**Nature of Work:** TILT UP PANEL, ROOF STRUCTURE(DECK & TRUSSES), 2ND FLOOR DECKING

# Sacramento City School Head Quarters Serna Center Mechanical Unit Anchorage Sacramento, CA

Serna Center Mechanical Unit Curb	
MSM#:	C0320
CLIENT:	Brown Construction
DATE:	04/18/02
SHEET:	SK041802-01

REVISED MECH UNIT MOUNTING DETAIL

PARTIAL MECHANICAL ROOF PLAN  
SCALE: 1" = 40'-0"

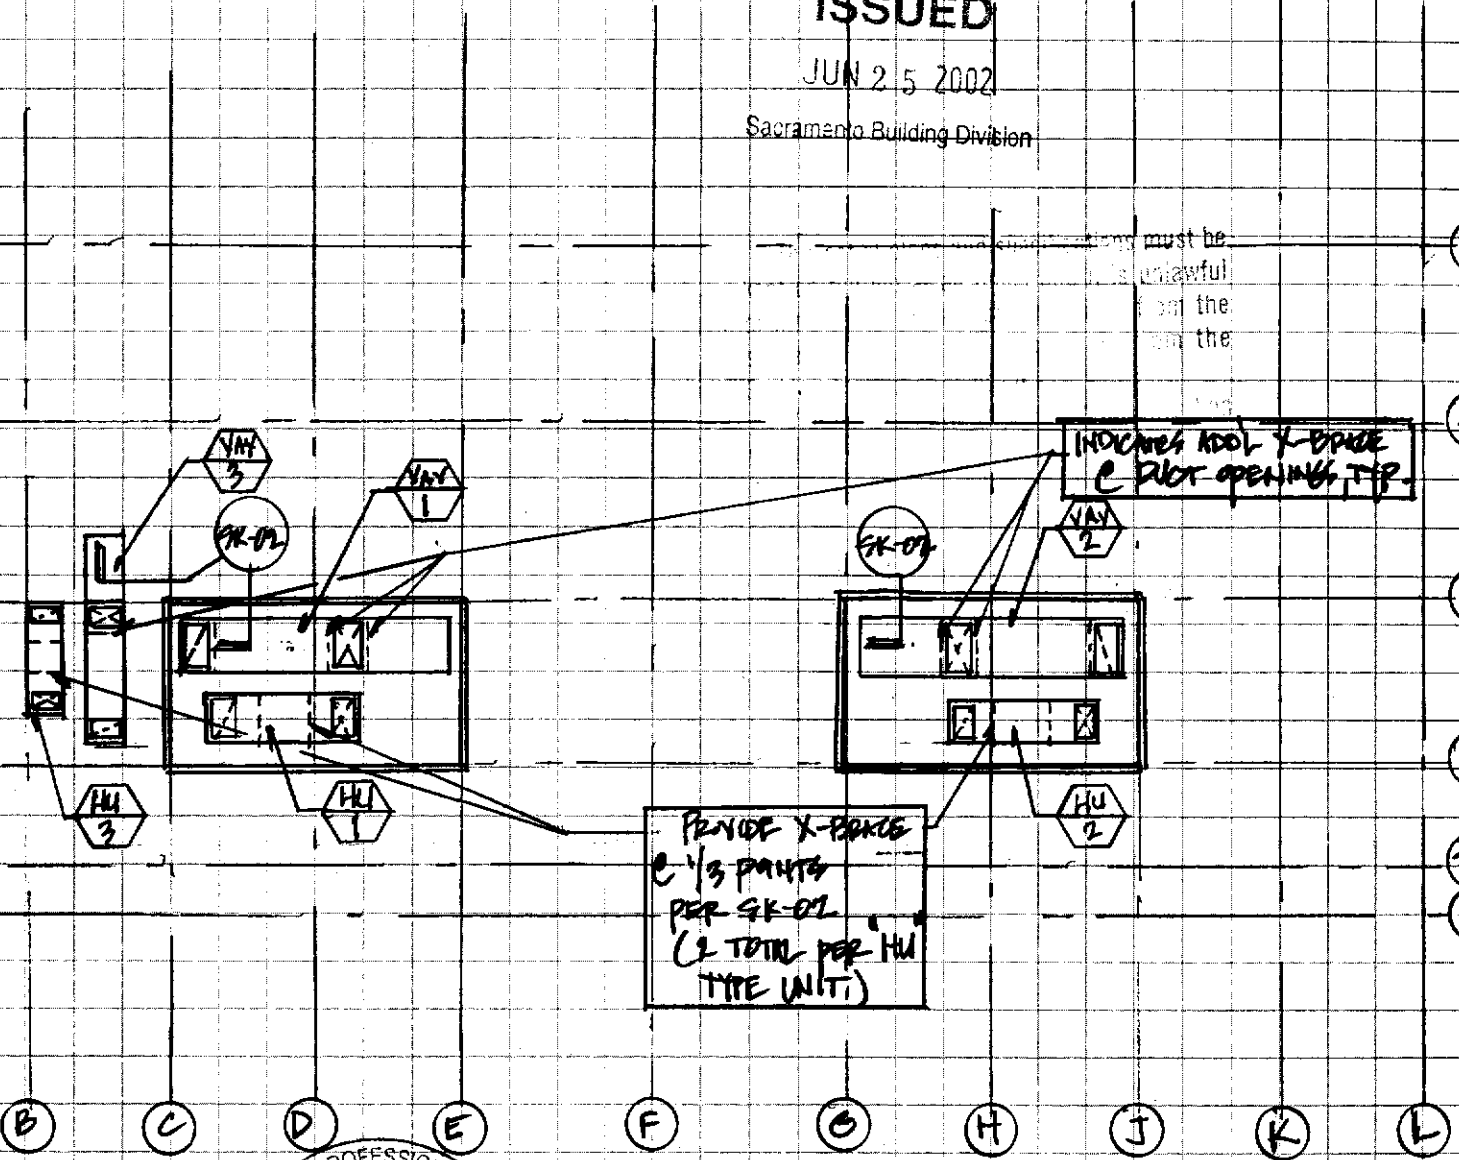
PROVIDE X-PANCK  
ON 1/3 POINTS  
PER SK-01  
(2 TOTAL PER HU  
TYPE UNIT)

INDOOR ACOIL X-PANCK  
ON DUCT OPENINGS
